# **Final 2017 Sampling Report Two-Party Site**

**Former Building 3564  
HQAES No. 02871.1076  
ADEC Hazard ID. 25015, File No. 108.26.028  
Fort Wainwright, Alaska**

ALASKA DEPT. OF ENVIRONMENTAL CONSERVATION		DATE: 3/27/2018 REVIEWER: Erica Blake/Dennis Shepard PHONE: 907-451-2182 (Erica) 907-451-2180 (Dennis)	Action taken on comment by: Karol Johnson and Vanessa Ritchie – FES (4/3/18)

CONTRACT: W911KB-16-D-0005      FIGURE: 3-1      DATE: 4/18

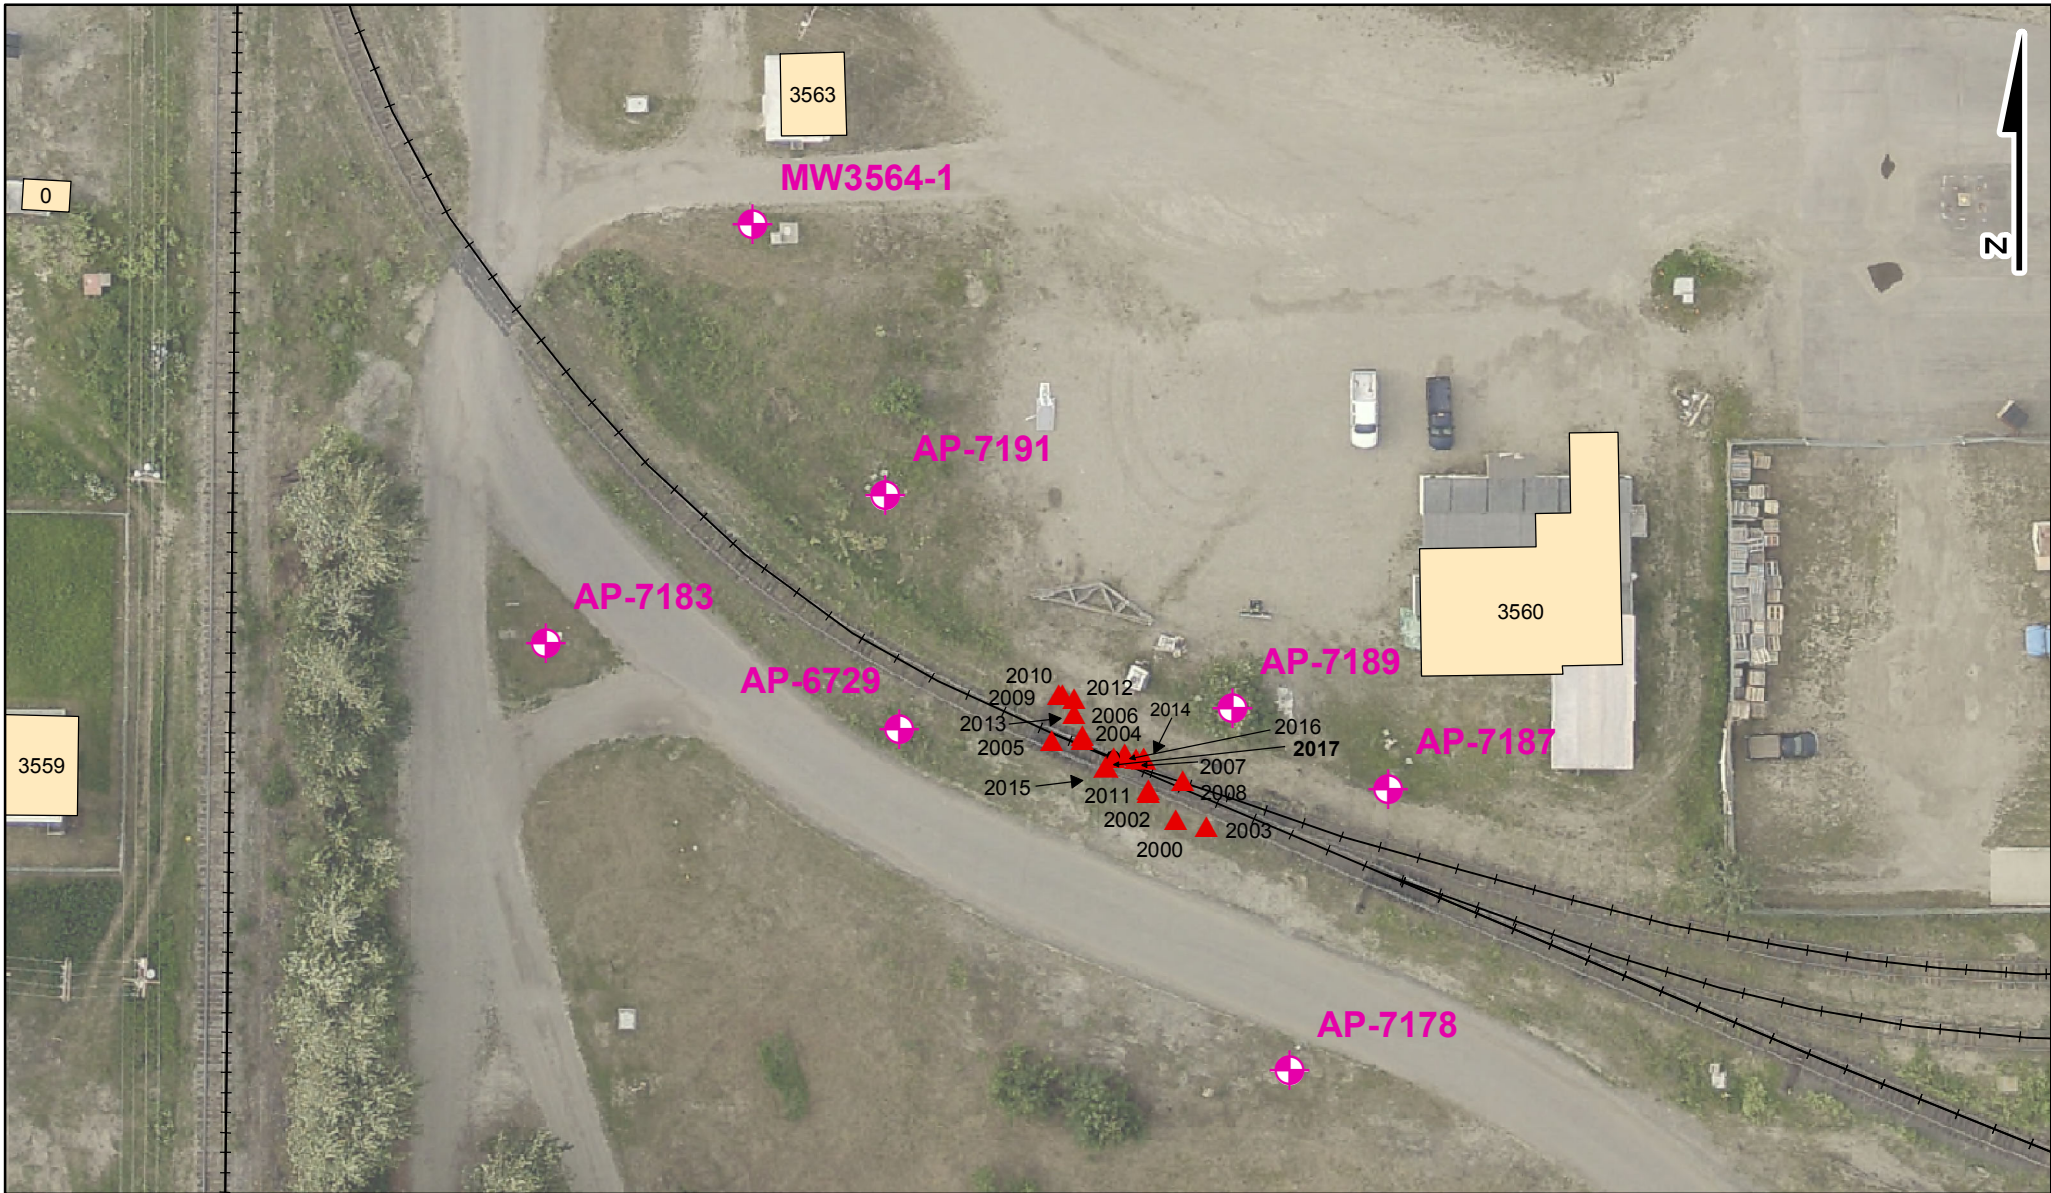
4.	Section 3.2, Page 3-2	Statement: "The DRO concentration in well AP-7187 decreased significantly during 2017 to 4,762 µg/L." The result for AP-7187 is not consistent between Figure 3-1 and the report text. Please revise so the two are consistent.	A	The Figure will reflect the DRO concentration of 4,762 µg/L in AP-7187.
